Access Compliance Report Public Rights-of-Way (Curb Ramps)

Main Street: ETHEREAL_RD Cross Street: SOL_ST Location: S

ADA ID: RPRK211104124058 Ramp Type: Type 1 - Perpendicular Initial Pass/Fail: Pass Overall Compliance: No Severity Score: 15

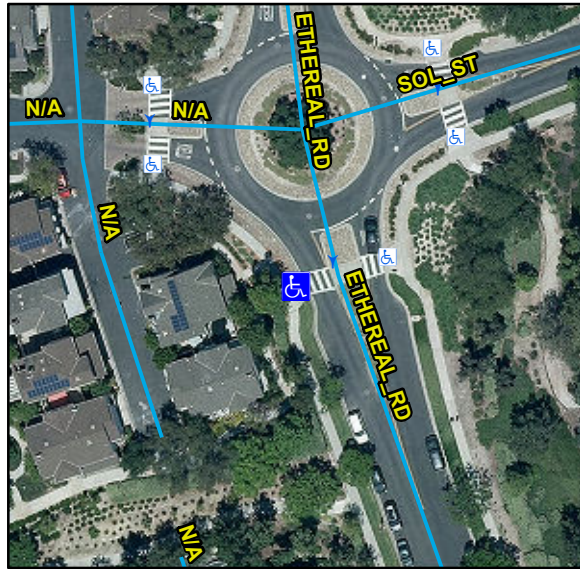
R304.2.2, R305, R304.5.4, STD 1115

Yes	Ramp Inside Crosswalk 1	Yes	Yes	Ramp Inside Crosswalk 2	N/A
	Crossing 1 Slope (%)	5		Crossing 2 Slope (%)	N/A
	Crossing 1 Cross Slope (%)	1.2		Crossing 2 Cross Slope (%)	N/A
Yes	Gutter Ponding	No	No	Curb Slope	13.9
Yes	Gutter Lip Height (in)	0		Road Run Slope (%)	N/A
No	Gutter Run Slope (%)	7.4		Road Cross Slope (%)	N/A
Yes	Gutter Cross Slope (%)	1.7			
Yes	Overall Surface Condition: Acceptable		Yes	Perp Joint Present	Yes
	Cross Gutter Present?	No		Spandrel Present?	No
	Replace Cross Gutter?	N/A		Replace Spandrel?	N/A

Remove & Replace Entire Ramp. Remove & Replace Gutter.
